# CITY OF HIGH POINT AGENDA ITEM

Title: Samet Corporation Change Order - #004		
<b>City Lake Park Phase 1 Renovations</b>		
<b>From:</b> Lee Tillery, Parks and Recreation Director Bobby Fitzjohn, Financial Services Director	Meeting Date: July 18, 2022	
Public Hearing: N/A	Advertising Date: N/A	
	Advertised By: N/A	
Attachments: Samet Corporation – Change Order - #	004	
Traxx Racer Rendering		
Capital Project Ordinance

# Potential Change Order

DESCRIPTION OF WORK: CE #047 - Slide Retaining Wall

2. Racing /Dispatch System with Truss ADD

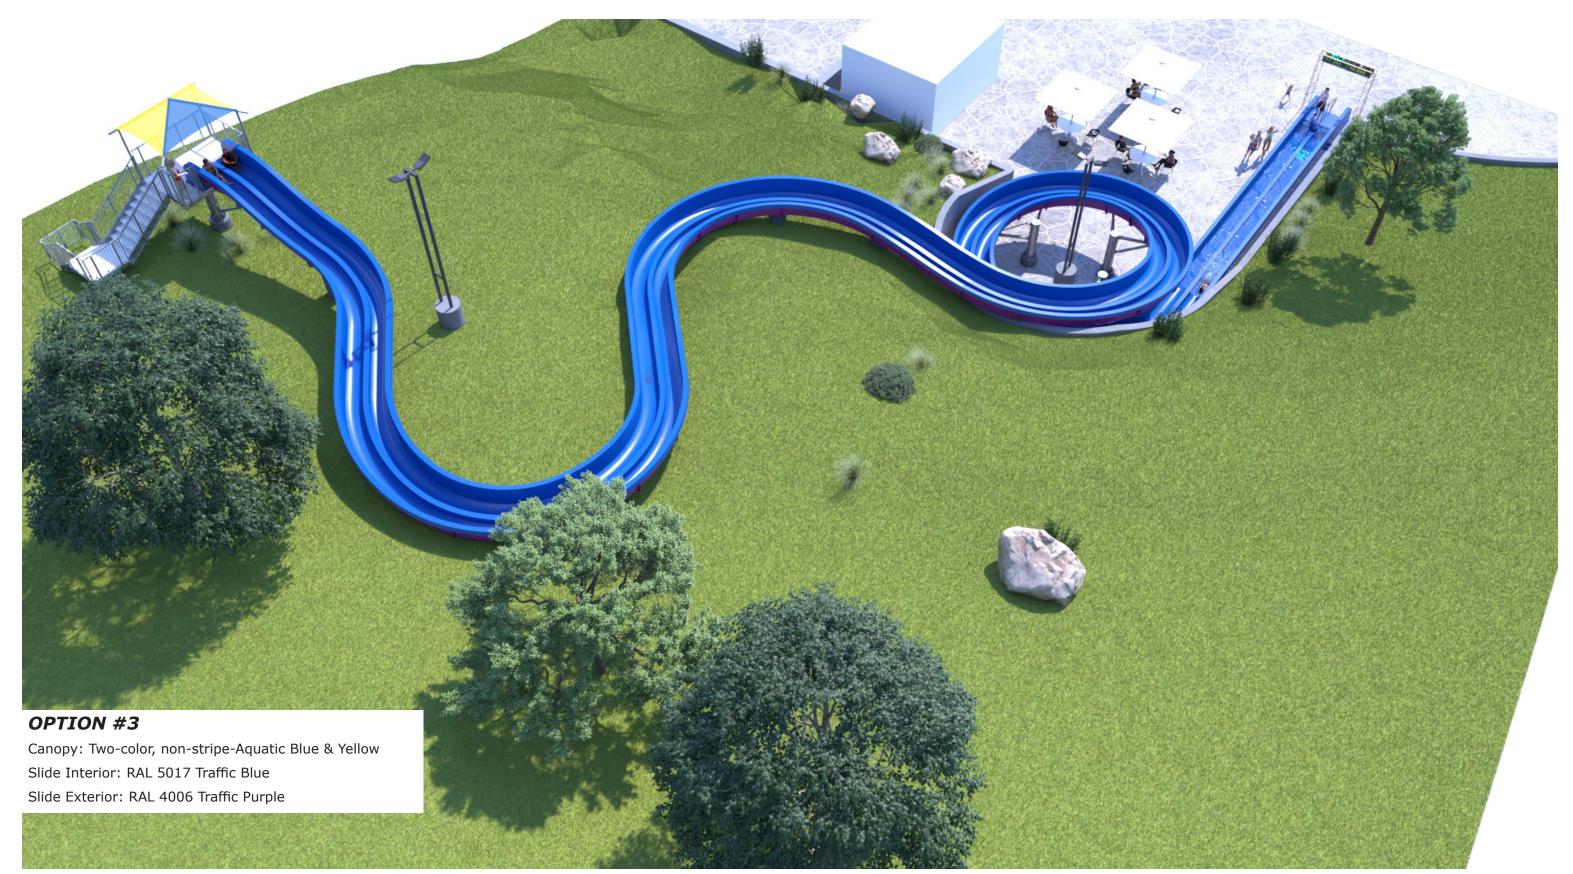
Traxx Dual Racer Slide Loop Retaining Walls, Surveying, Concrete, Rails, Grading & Storm Drainage.

CE #077 - Slide Change to Racer

5 additional sets of depth markers, increase wall suction port and piping to 12", swap out slide to racer, increase in size and magnitude of slide vault, increase slide pump and VFD HP, larger grating for the slide vault, increase size and structure of valve pits, additional piping for play feature, add concentric reducing strainer and additional basket, modify one of the completed strainers, upgrade P7 and VFD to 20 HP, fabricate 2 new custom main drains with increased port size

<u>CE #085 - Slide Retaining Wall - Fence</u> Fence for the top of the retaining wall at the Dual-Racer waterslide
